DESIGN <i>CP</i>	DRAWN BY <i>CP</i>	<b>DART AEROSPACE LTD</b> HAWKESBURY, ONTARIO, CANADA	
CHECKED <i>[Signature]</i>	APPROVED <i>[Signature]</i>	DRAWING NO. DSI 9202	REV. A SHEET 1 OF 1
DATE 01.04.20		TITLE BASKET HINGE CHANGE	SCALE NTS
A	01.04.20	NEW ISSUE

## **DART SERVICE INSTRUCTION**

**TO AMEND INSTALLATION DRAWING D205-541 REV. D**  
(REF. CANADIAN STC: SH96-120, FAA STC: SR00696NY)  
**AND INSTALLATION DRAWING D350-607 REV. E**  
(REF. CANADIAN STC: SH94-14, FAA STC: SR00213NY)

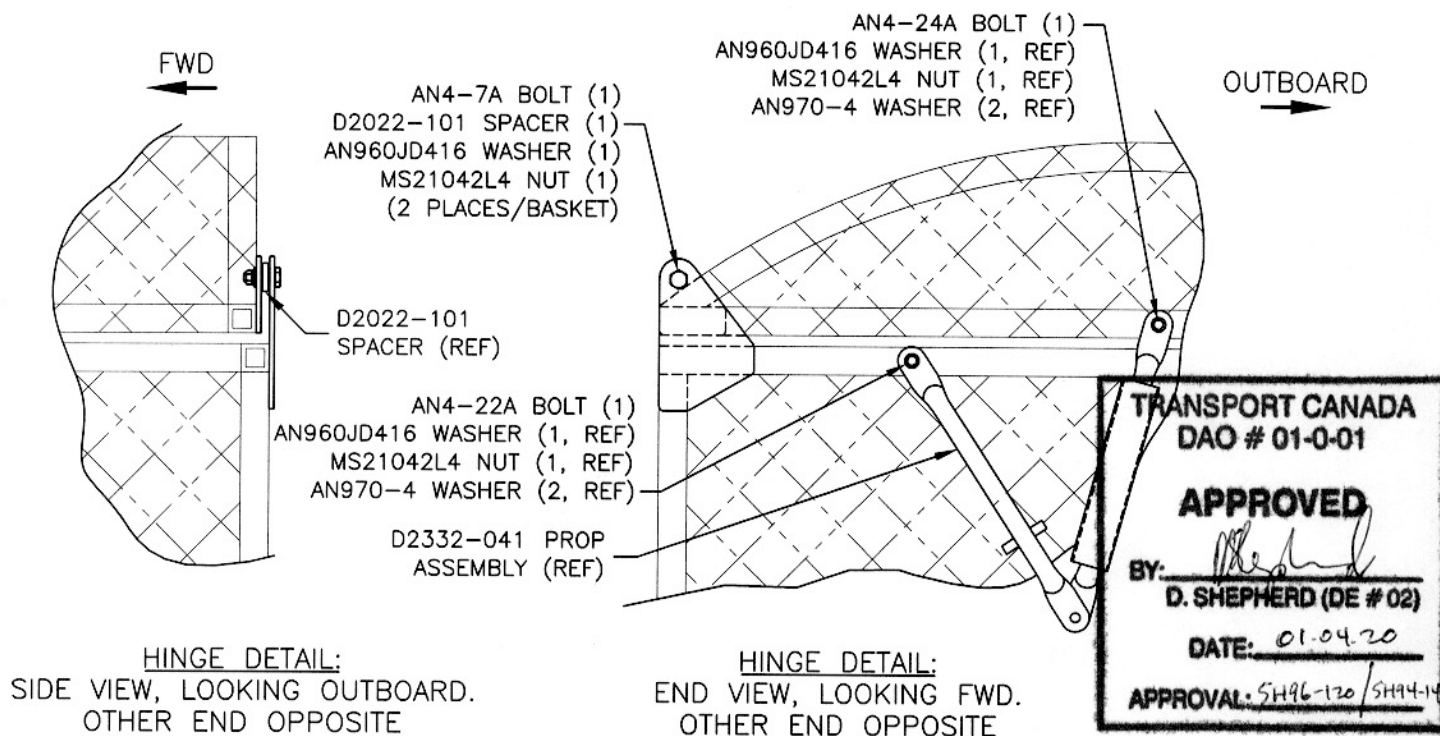
THE PARTS LIST OF D205-541 REV. D (205-541-041 CHG 004 OR LATER) / D350-607 REV. E (D350-607-041/-042 CHG 005 OR LATER) SHOULD BE AMENDED AS FOLLOWS:

REMOVE:

Qty	Part Number	Description
1	D2569	HINGE
36	AD64ABSLF	RIVET
1	AN4-22A	BOLT*

\* NOTE: AN4-22A SUBSTITUTED FOR AN4-23A PER DSI 9159 REV. A  
ON D205-541-041

ADD:

Qty	Part Number	Description
2	D2022-101	SPACER
2	AN4-7A	BOLT
1	AN4-24A	BOLT
2	AN960JD416	WASHER
2	MS21042L4	NUT (OR MS21042-4)
